Access Compliance Report

Public Rights-of-Way

Intersection ID: 52521	Main Street: LORNA_ST	Cross Street: MCCLINTOCK_RD	Location: W
ADA ID: FFEF070F748A	Ramp Type: BlendTrans1	Initial Pass/Fail: Pass	Overall Compliance: No
Severity Score: 0.25			
Codes/Mitigation Info/Possible Solution		Field Measurements/Component Compliance

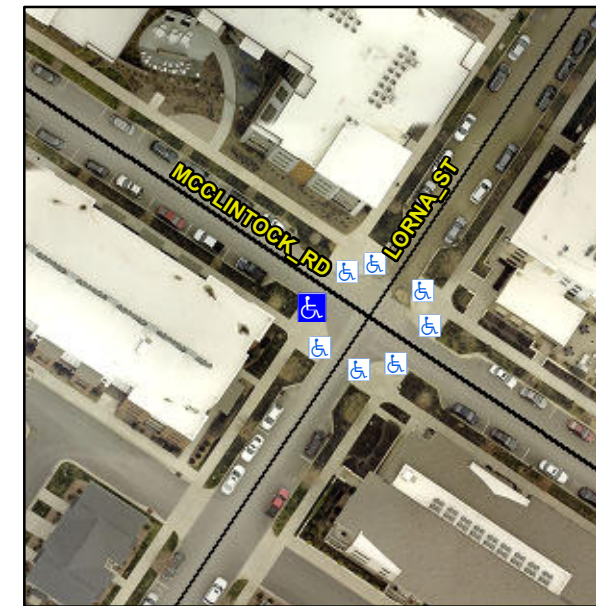
R304.5.3, R305.2

Compliance	Description	Data	Compliance	Description	Data
N/A	Ramp Length (in)	68.0	Yes	BlendTrans Slope (%)	5.0
Yes	Ramp Width (in)	72.0	No	BlendTrans XSlope (%)	2.3
N/A	Flare Type LT	Sloped	N/A	Flare Type RT	Sloped
Yes	Flare Slope LT (%)	5.2	N/A	Flare Slope RT (%)	9.0
N/A	Flare Traversable LT?	Yes	N/A	Flare Traversable RT?	No
Yes	Landing Length (in)	73.0	Yes	DWS Provided?	Yes
Yes	Landing Width (in)	71.0	Yes	DWS Contrast?	Yes
Yes	Landing Slope (%)	0.9	Yes	DWS Length (in)	24.0
No	Landing X Slope (%)	2.6	Yes	DWS Full Width?	Yes
N/A	Landing Curb? (Y/N)	No	No	DWS Offset (in)	5.0
N/A	Shared Landing?	Yes			
Yes	Gutter Ponding?	No	Yes	Gutter Slope (%)	3.8
Yes	Gutter Lip Ht (in)	0.0	Yes	Gutter X Slope (%)	0.7
N/A	Painted X Walk1?	No	N/A	Painted X Walk2?	N/A
	X Walk 1 Direction	To NE		X Walk 2 Direction	N/A
	X Walk 1 Width (in)	N/A		X Walk 2 Width (in)	N/A
	X Walk 1 Slope (%)	3.9		X Walk 2 Slope (%)	N/A
	X Walk 1 X Slope (%)	0.7		X Walk 2 X Slope (%)	N/A

Remove & Replace Curb Ramp With Two New Directional Ramps or Equivalent.
